FIRST DRAFT MINUTES

December 18, 2014 Standards Committee Meeting

RE: Minutes from the December 18, 2014 Standards Committee Meeting

402-NVUF-01 HMA NONMOTORIZED-VEHICLE-USE FACILITY PAVEMENT SECTION (WITH MARKUPS)

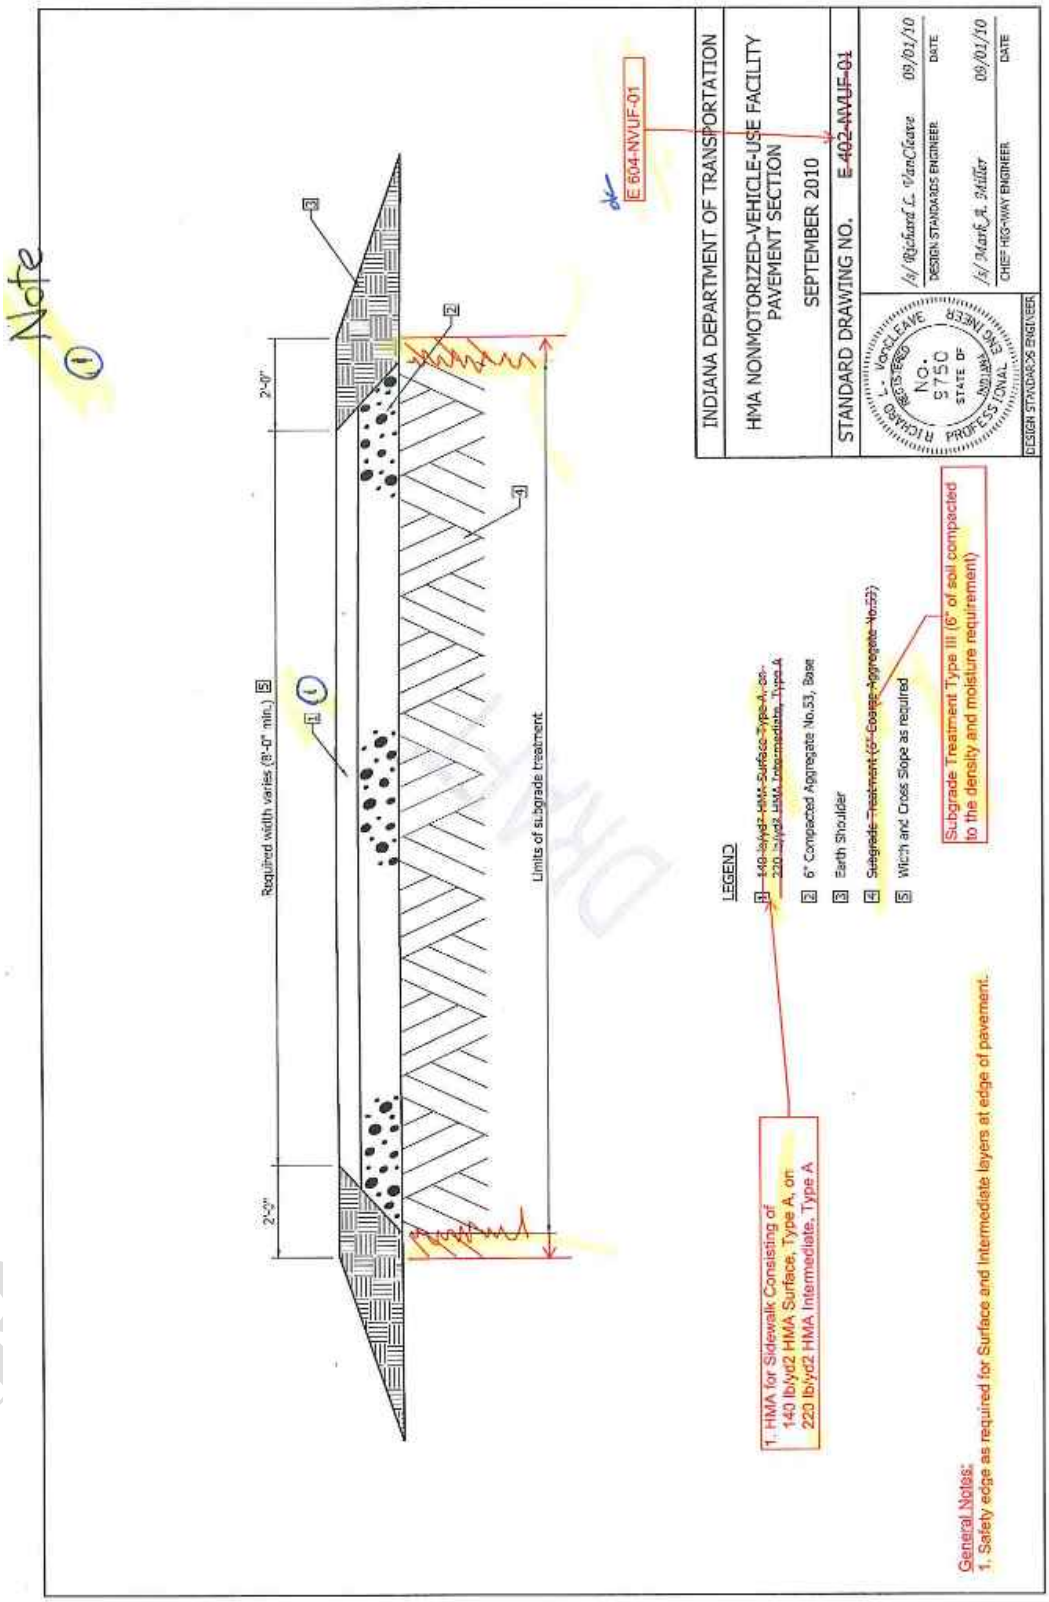
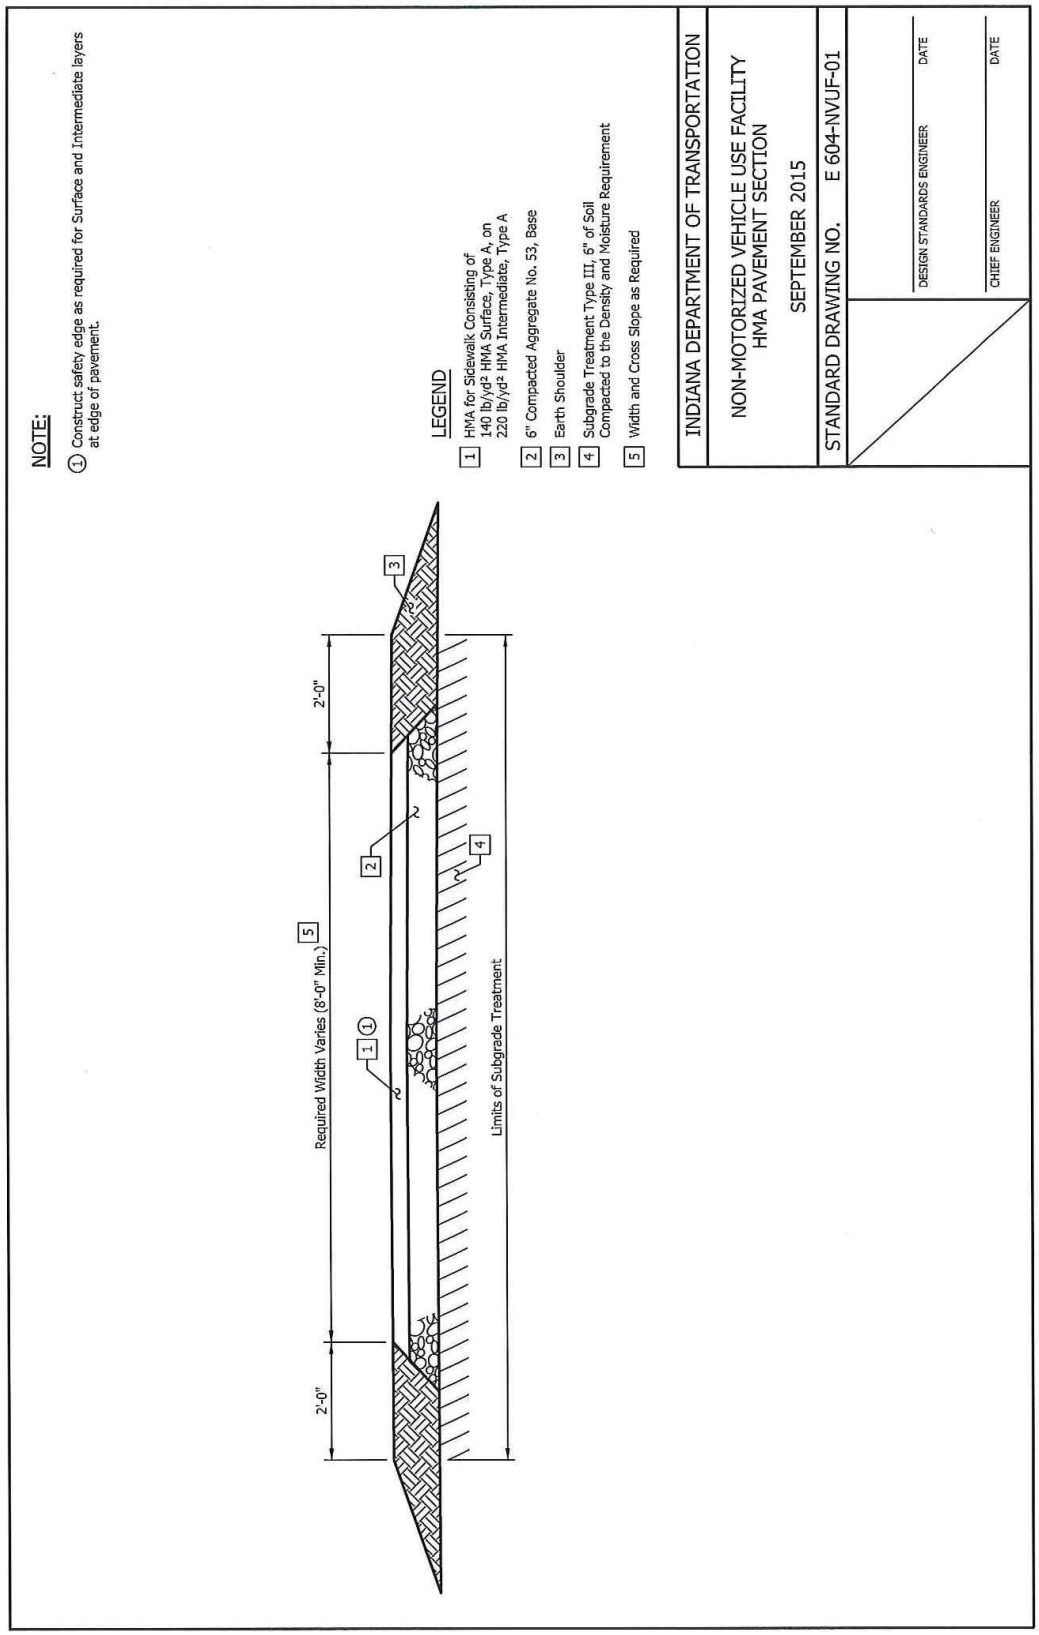
PROPOSED SOLUTION: Revise the E 402-NVUF series to be paid for as HMA for Sidewalk and the E 502-NVUF Concrete to be paid for as Sidewalk Concrete. Update 3-digit lead number to 604 to coordinate with appropriate section of the Standard Specifications.

DISCUSSION:
This item was introduced and presented by Ms. Phillips who expressed the need to revise the E 402-NVUF series, and the E 502-NVUF series drawings to 604 in order to coordinate with the appropriate, 604, section of the Standard Specifications.

PROPOSED REVISION 703-BRST-01 BAR BENDING DETAILS (DRAFT)

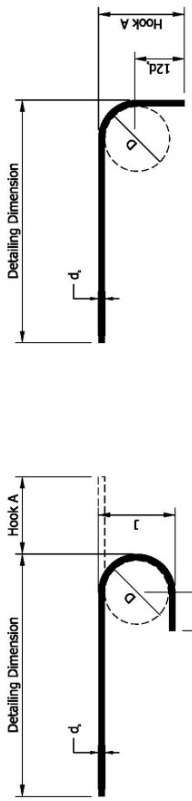
PROBLEM(S) ENCOUNTERED: There are inconsistencies between IDM Figure 405-2Y and Std Dwg E703-BRST-01 regarding the size and dimension for standard reinforcing bar hook details. Neither is completely correct.

PROPOSED SOLUTION: Revise both the Figure and Standard Drawing to be in accordance with ACI 318 and CRSI's Manual of Standard and Practice.
ACI= American Concrete Institute
CRSI = Concrete Reinforcing Steel Institute

DISCUSSION:
Ms. Phillips introduced and presented this item suggesting that Figure 405-27 of the Indiana Design Manual and Standard Drawing E 703-BRST-01 be revised in accordance with ACI 318 and CRSI's Manual of Standard and Practice.
